IN no.: **IN-149 rev 1.1**

**nRF52833-QIAA, nRF52833-QDAA and nRF52833-CJAA**

## Description of change:

The nRF52833 revision 2 (build code Bx0) introduces four changes to the product.

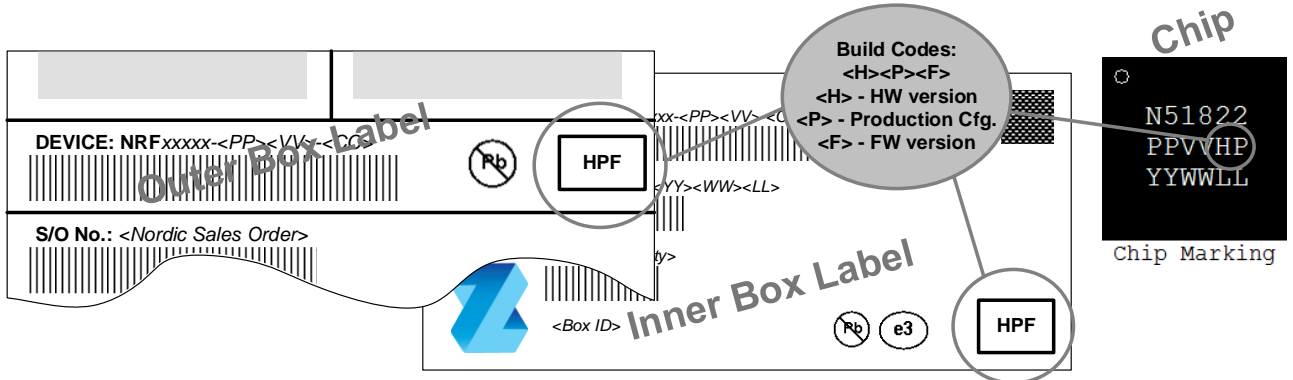
*Changes to pin-out:*

Existing PCB designs for the nRF52833 (rev. 1) are compatible with the nRF52833 rev. 2 without performance degradation. For new designs an updated bill of material for the reference schematic is available in the product specification rev. 1.4 or later. The new bill of material requires one less decoupling capacitor.
